AR-07-0302

Southern Nuclear Operating Company
Vogtle Early Site Permit Application
Safety Review Site Audit Hydrology Information Needs

Enclosure: Responses to NRC Site Hydrology Information Needs From January 2007 Safety Review Site Audit For the Vogtle ESP Application

Information Needs from the January 2007 Safety Review Site Audit

Item #1 Figure 1

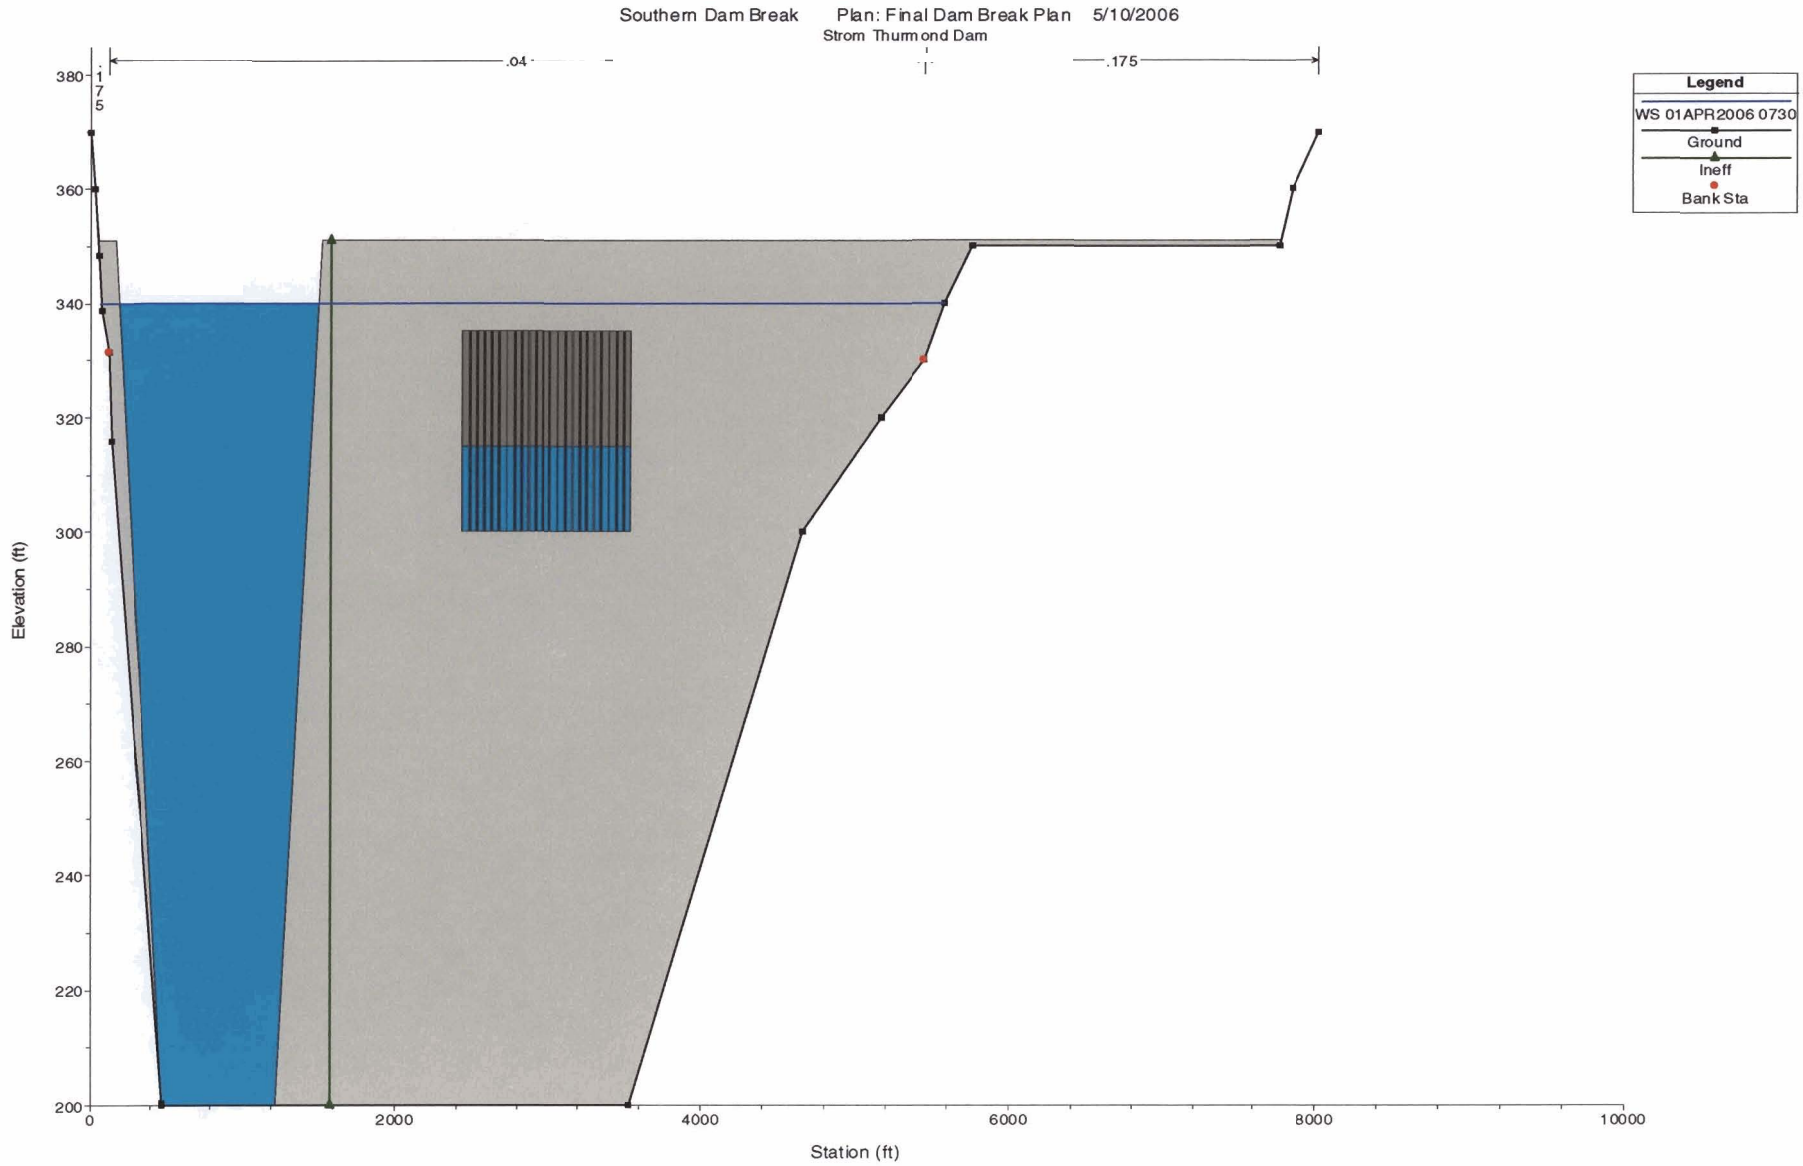
Item #1 Present the calculations used to estimate the dam breach parameters discussed on page 2.4.4-4 and outlined in the USBR.

2) As shown on Item #1 Figure 1 of this response, the total dam width at the top of the dam is about 5,700 ft. (Reference 2). The width of the dam at the upstream invert elevation (El. 200 ft) is about 2,840 ft. Located within the portion of the dam that extends to El.. 200 ft is a concrete embankment section 2,282 ft wide where the tainter gate spillways and powerhouse are located (Reference 2). The failure mode assumes that only the earth section of the dam will erode during the breach. Consequently, the 755-foot bottom width of the breach extends beyond the area in which the actual ground elevation is at the minimum ground elevation of El. 200 ft.

3) Superposing the 755-foot bottom width at El 200 ft on the cross-section of the valley on the upstream side of the dam shows that more than 200 feet of the breach would be above El. 200 ft. Therefore, the entire bottom of the breach was taken as El. 200 ft to be conservative. The cross section shown in Figure 1 has been artificially widened at El. 200 ft to accommodate the 755 ft wide breach.

Based on a review of data and analyses for 84 dam failure cases, and the physical layout of J Strom Thurmond Dam, a breach width of 755 ft, with 2 to 1 side slopes was selected for this analysis. Additionally, most of the breach time predictions are close to 1.0 hour. Thus, a breach time of 1.0 hour was selected for this analysis.
